ADDENDUM NO. 5

DATE: March 18, 2020

PROJECT: Hammond High School Renovation and Addition
Columbia, Maryland
Architect Project No. 18011

2 / A0.50 ROOF PHASING PLAN

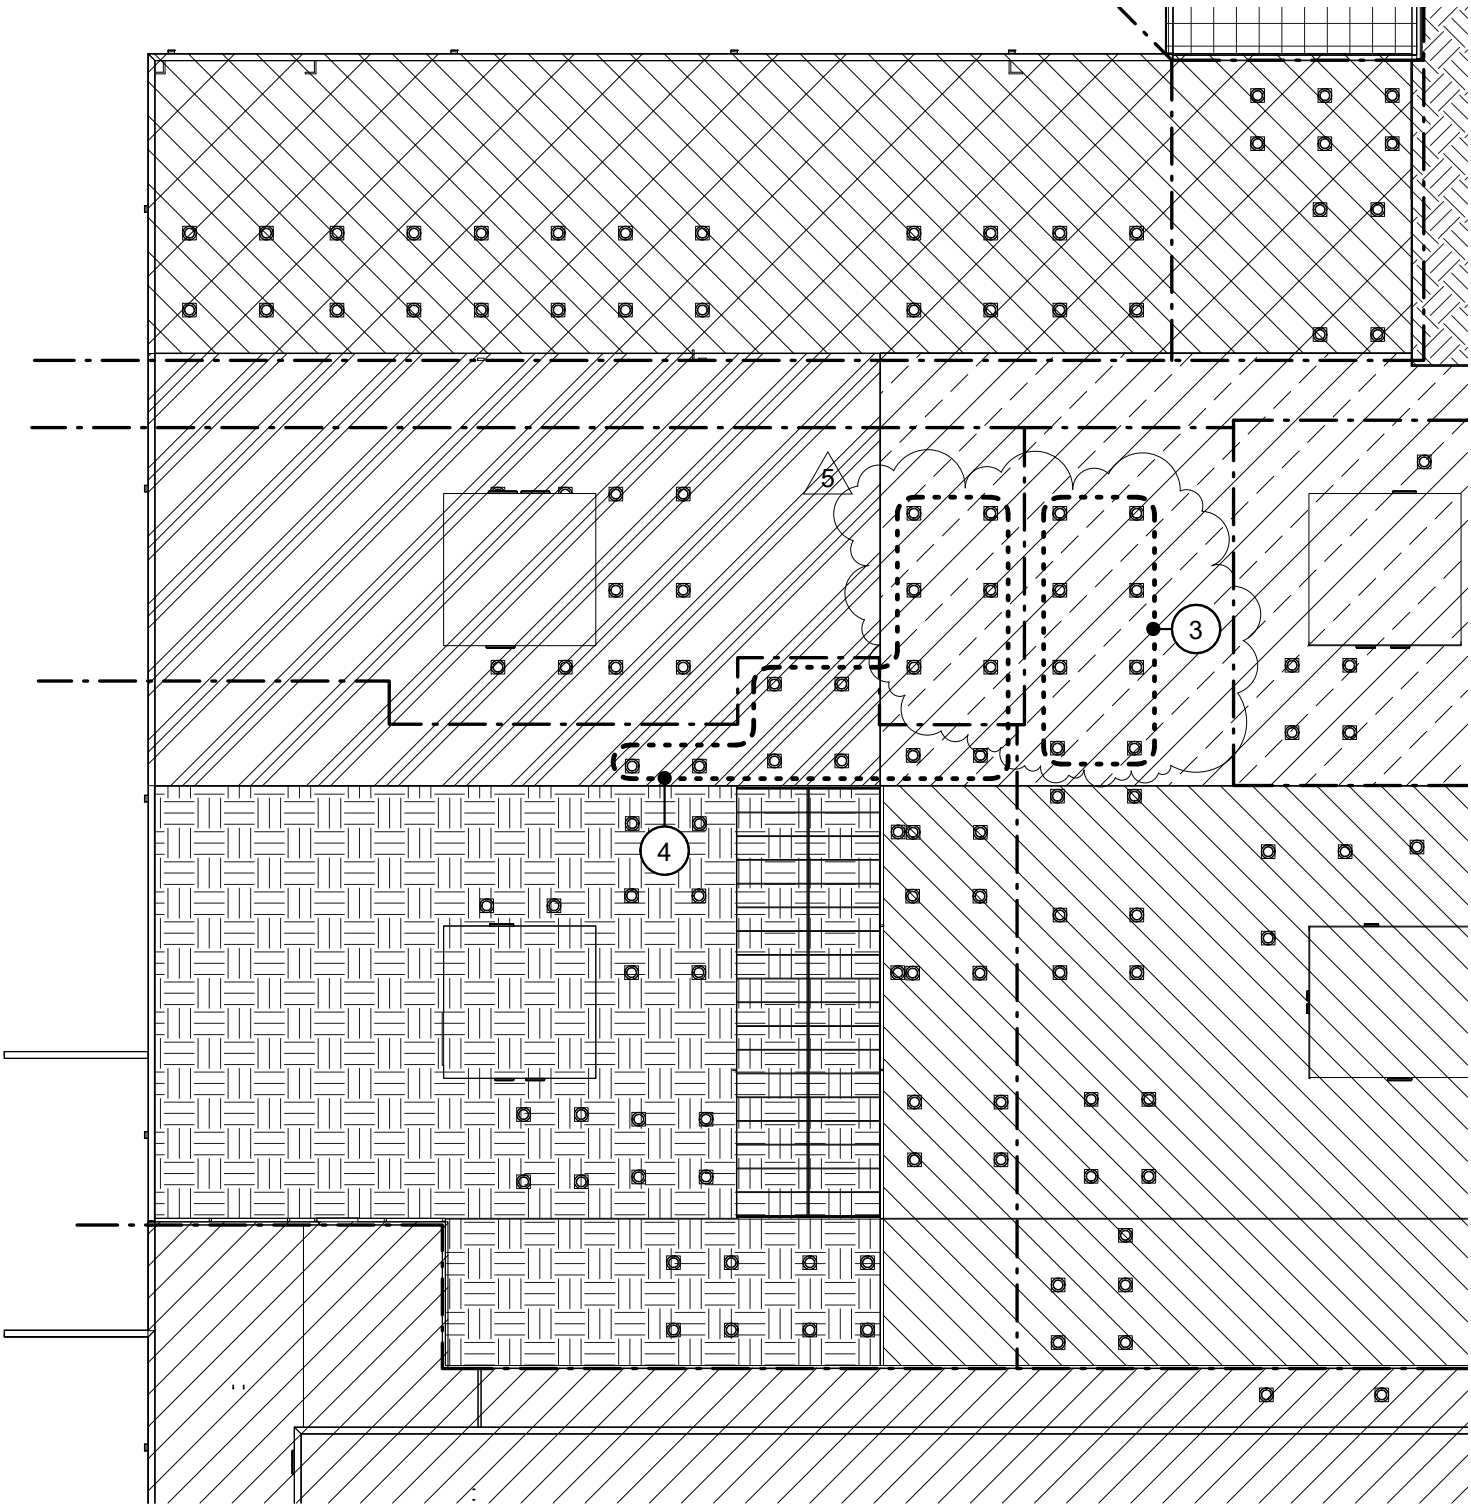
- ❑ A0.50 - OVERALL PHASING PLAN
  - **REVISE** detail 2/A0.50 to modify phasing of tubular daylighting devices as shown in sketch AD-A09
- ❑ A2.09 – FLOOR PLAN - FLOOR 2 - AREA H & PENTHOUSES 3, 4, 5, 6 & 7

1 / A2.57 AUDITORIUM RCP PLAN / H121 - H131 AND H133

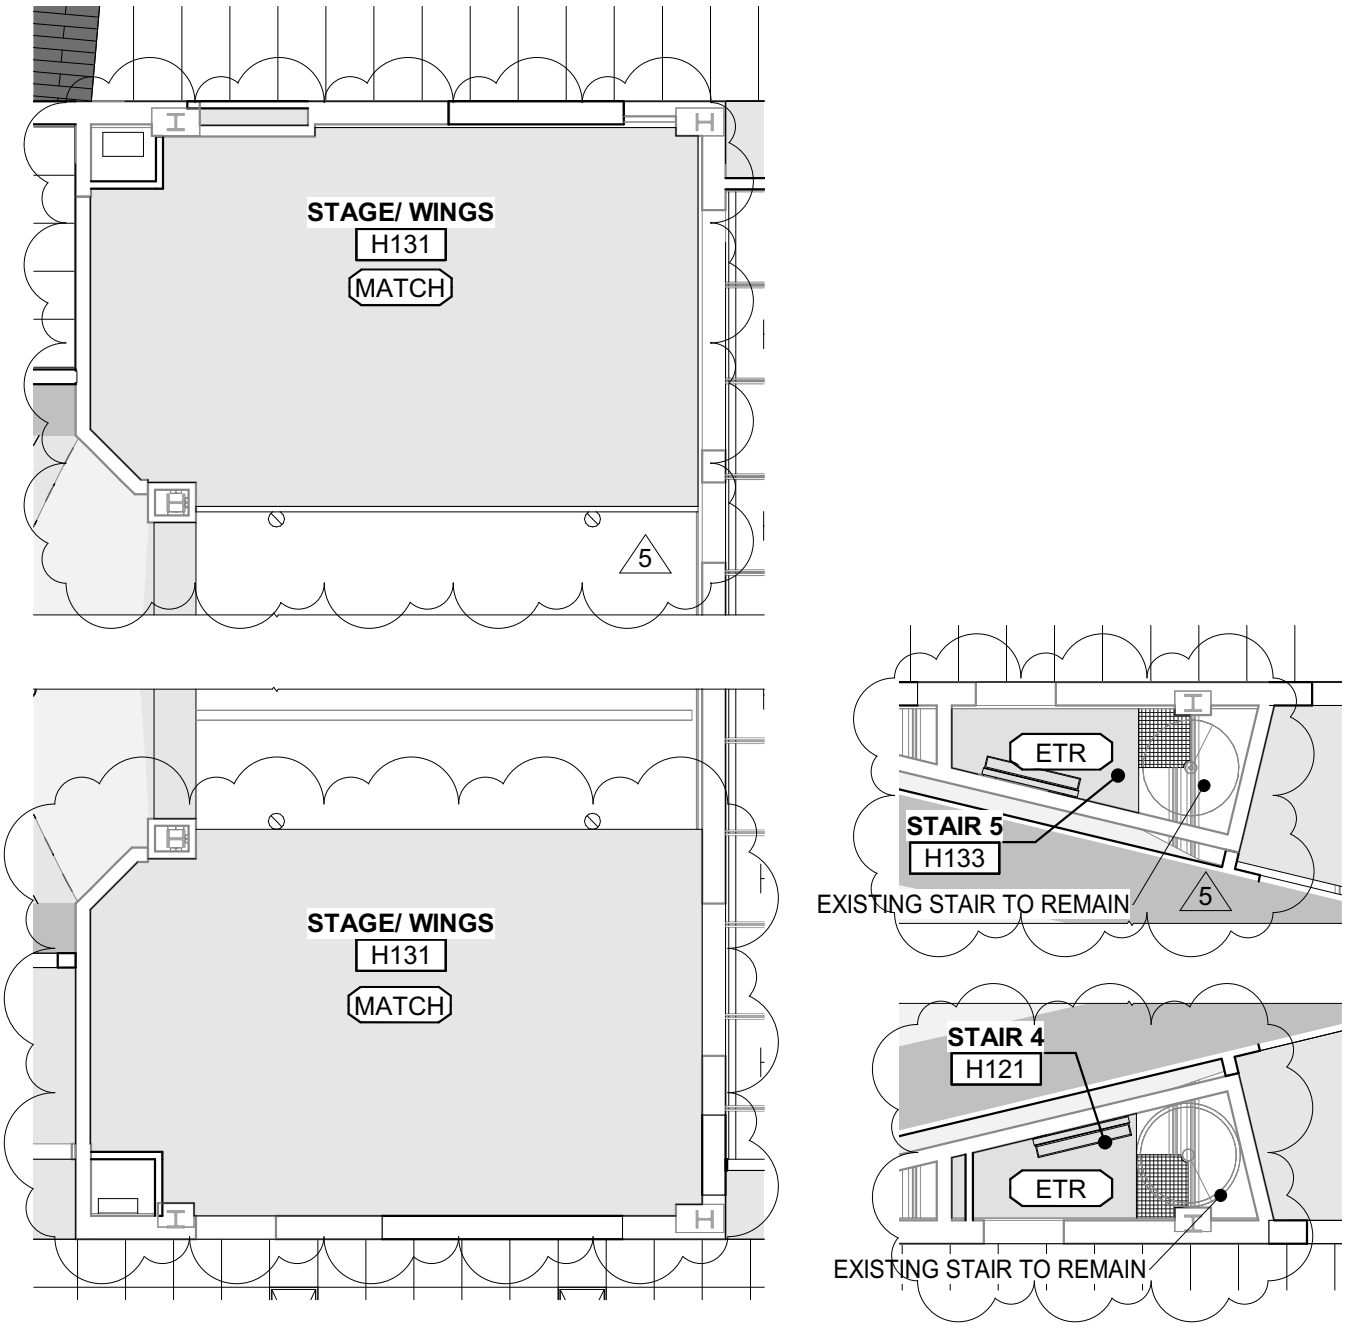
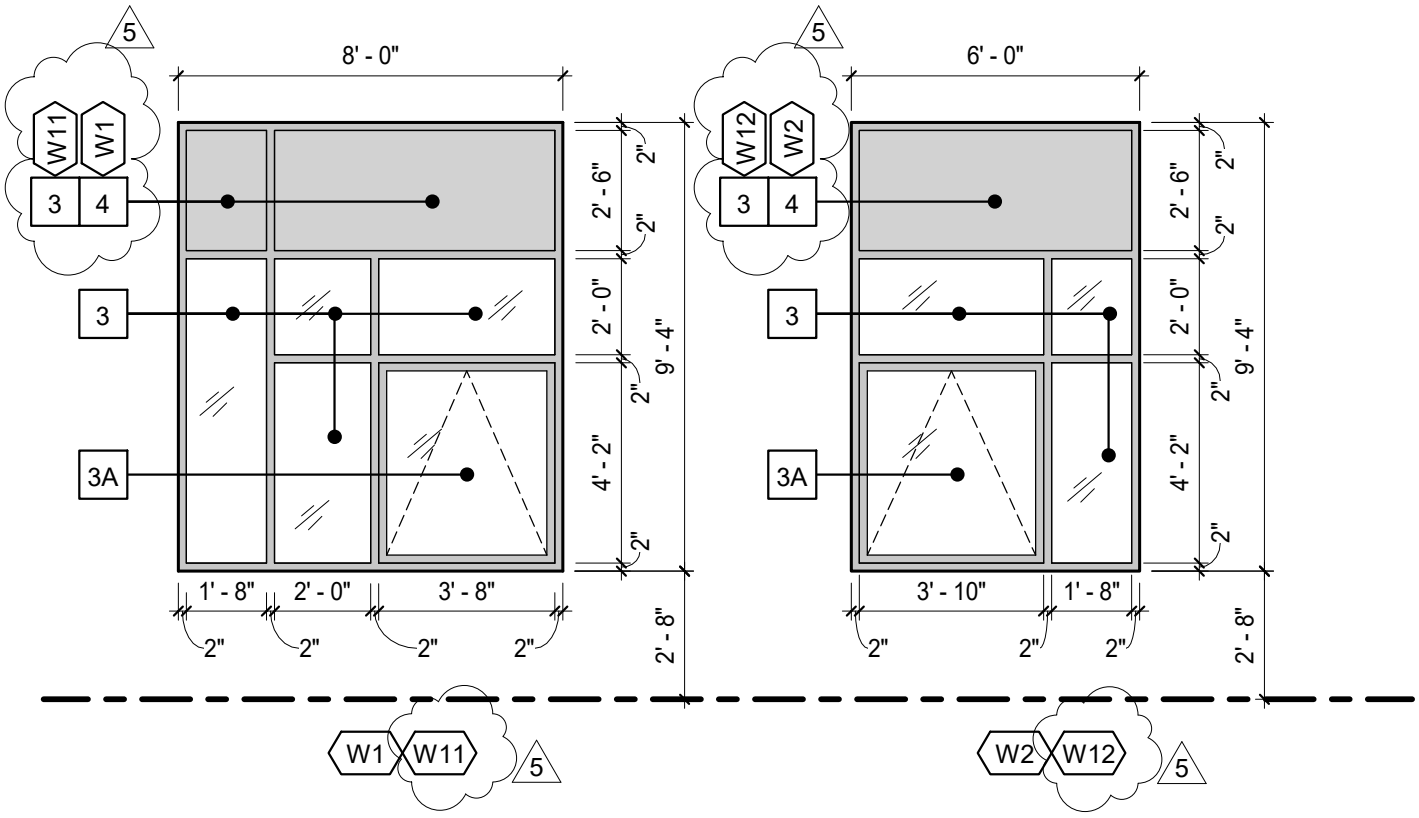
- **REVISE** floor hatching to clarify existing vs. new concrete work in penthouses. See reissued sheet.
- ❑ A2.57 – RCP – FLOOR 1 – AREA H
  - **REVISE** ceiling in stage wings and existing spiral staircases as shown in sketch AD-A11

WINDOWS W11 & W12

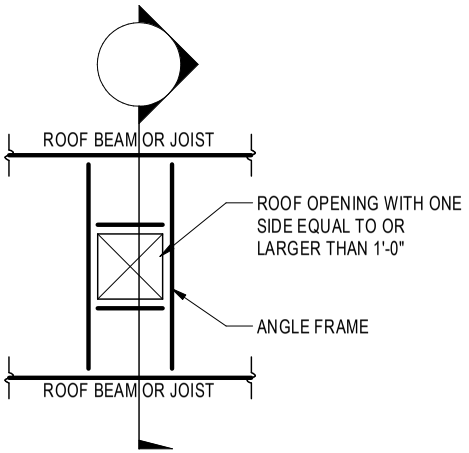
- ❑ A8.03 – WINDOW, CURTAIN WALL AND STORE FRONT SCHEDULE
  - **REVISE** Window schedule as shown in sketch AD-A12
- ❑ A9.21 – FINISH SCHEDULES AREA G, H, SECOND FLOOR, AND ALTERNATES

AD-S06

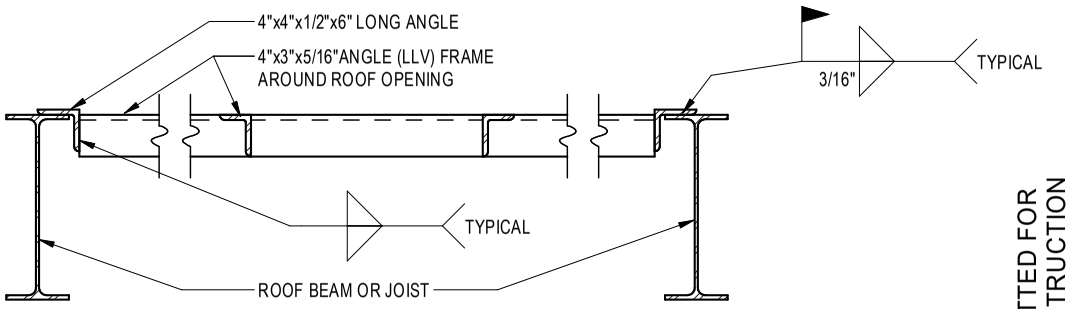
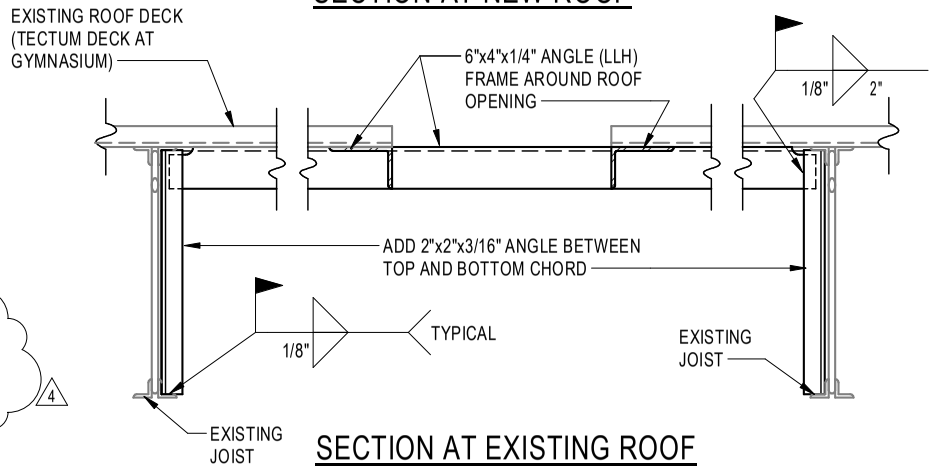
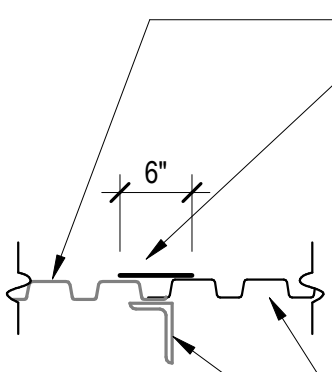
- ❑ Sheet S0.02 – INSPECTION TABLES AND SCHEDULES
  - **REVISE** Detail reference for Wall footing TWF
- ❑ Sheet S3.04 – TYPICAL STEEL FRAMING DETAILS
  - **ADD** Note for roof infill at damaged sections of roof deck
- ❑ Sheet S3.05 – TYPICAL STEEL FRAMING AND RENOVATION DETAILS
  - **ADD** Detail for roof infill.
